**CITY OF TEMPE
DEVELOPMENT REVIEW COMMISSION
REVISED**

**Meeting Date: 3/24/2015
Agenda Item: 1**

ACTION: Request for a Planned Area Development Overlay Amendment to establish development standards, a Use Permit for tandem parking, and a Development Plan Review for design of a ~~240~~17-room hotel, office, retail and restaurant uses within approximately 900,000 s.f. of new development, including the preservation of the Hayden House for a future phase restaurant use for MILL & RIO SALADO, located at 100 South Mill Avenue. The applicant is Manjula Vaz, Gammage & Burnham PLC.

Sheet Name:
HOTEL EAST
ELEVATION COLOR

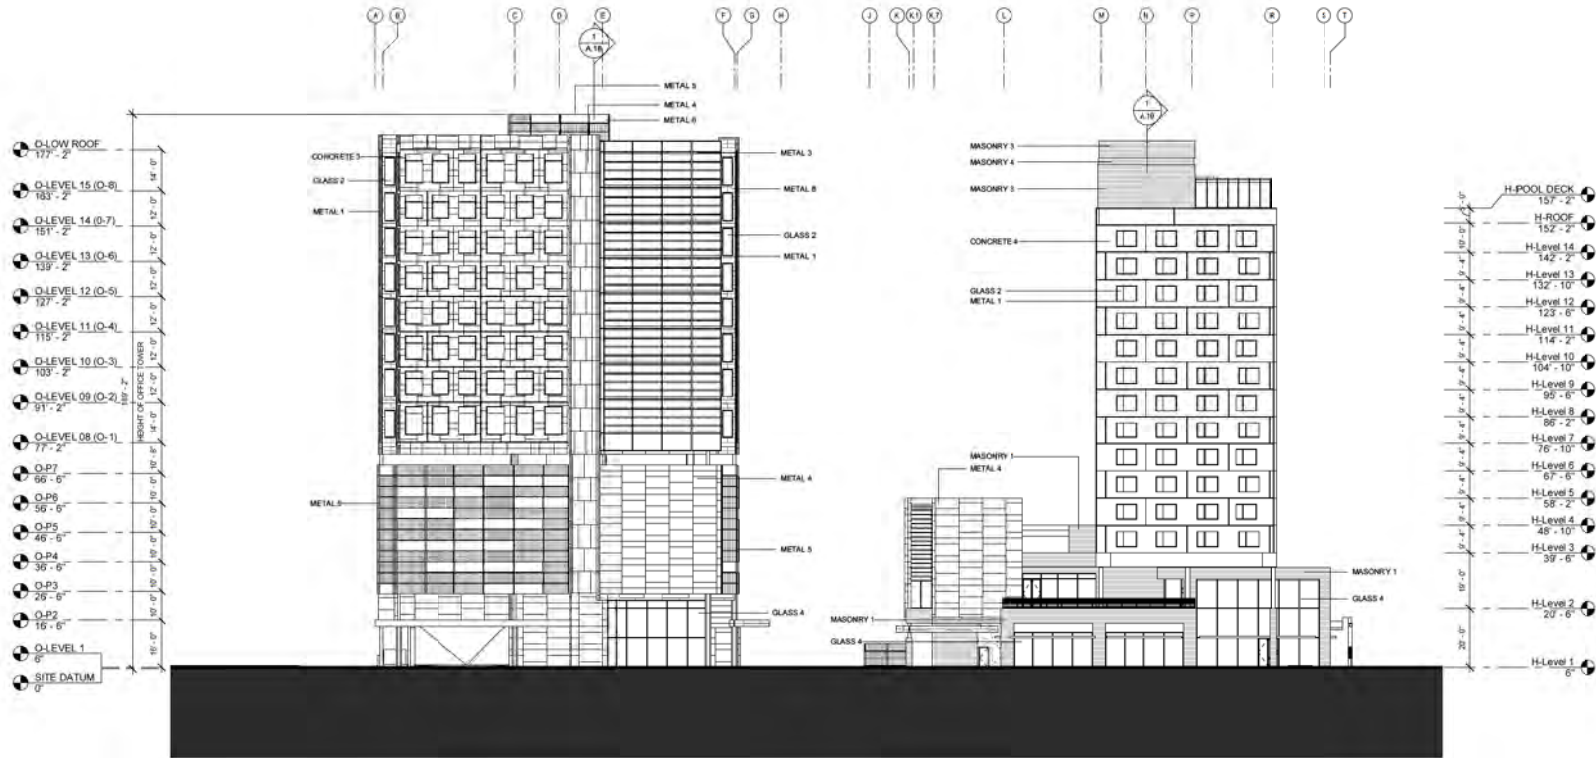
48. Provide design reference to the contextual relationship to the Flour Mill and the former Monti's site with the treatment of window mullions and recesses along the east elevation of the hotel.

Sheet Name:
 Planting Plan
 Sheet Number:
L2.0

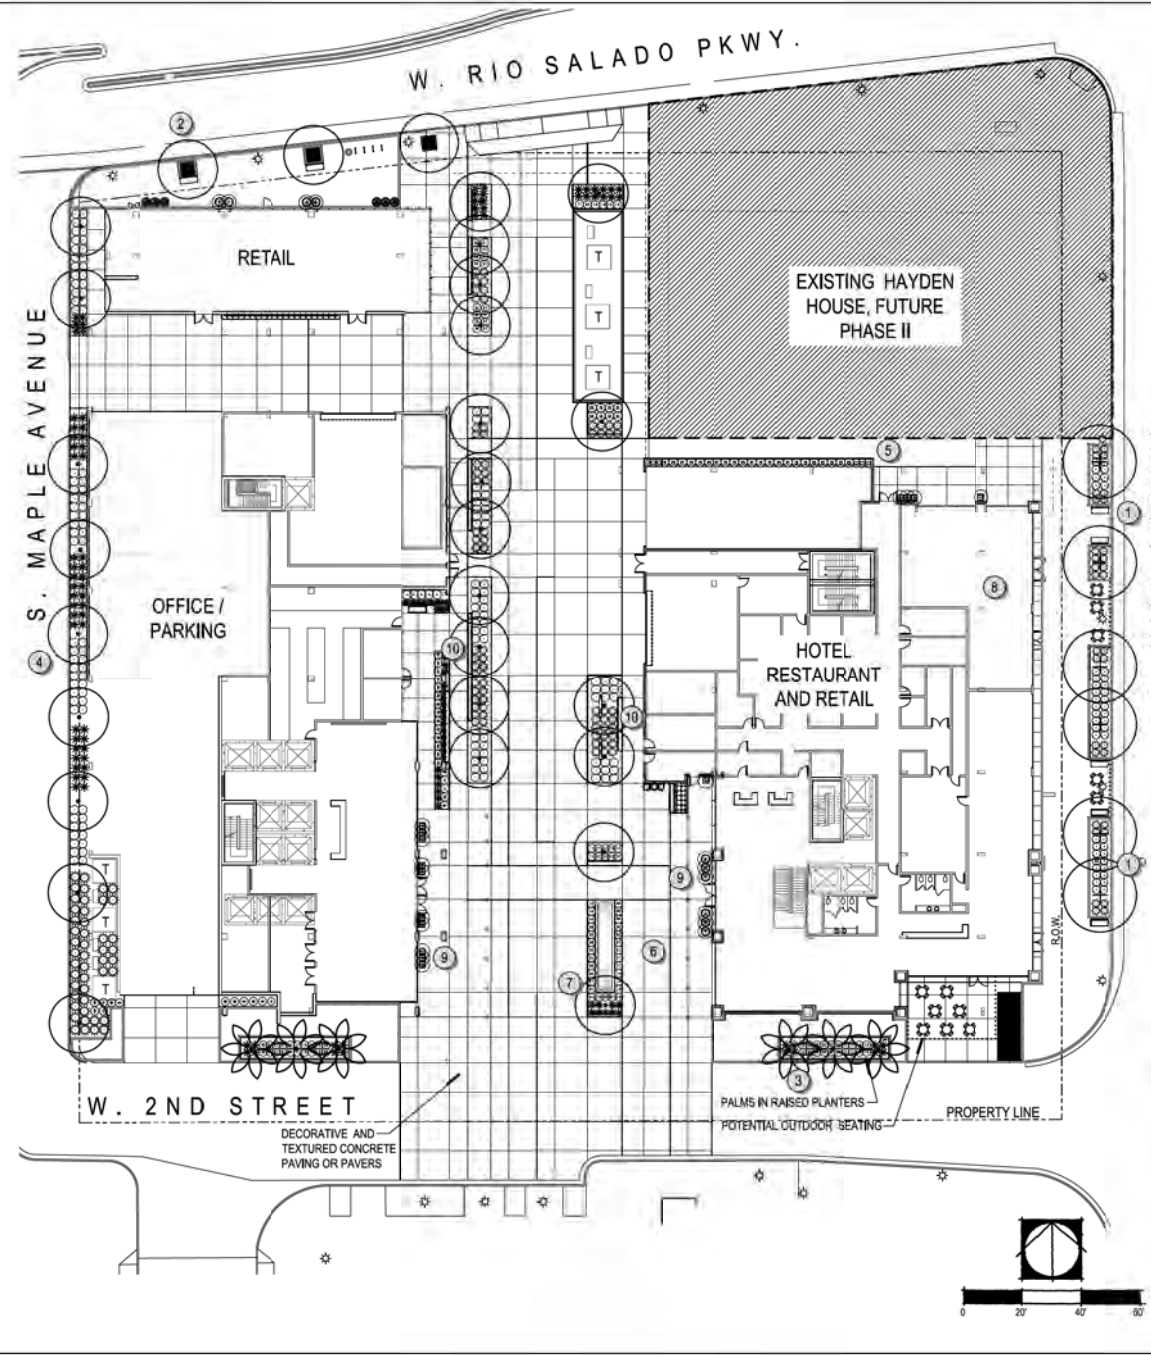
57. The plant palette is approved as proposed and specified on the landscape plan (dated March 9, 2015). With the following exceptions:

Maple Avenue to have a street tree distinct from Rio Salado Parkway and Mill Avenue, replace Heritage Live Oak with one of the following options: Eucalyptus papuana ghost gum, Acacia willardiana palo blanco, Acacia aneura mulga, Acacia salicina willow or Blue palo verde.

Replace the Heritage Live Oak in the interior courtyard to have tree varieties that can grow in a reflective heat condition and withstand growth in a limited root area (bounded by parking structure below and planter box sides): Thevetia peruviana, Cascalote 'Smoothie', Chaste tree, Sophora secundiflora, Bauhinia, Cordia boissieri, Acacia farnesiana 'Sierra Sweet' or Olea europaea 'Swan Hill' olive.
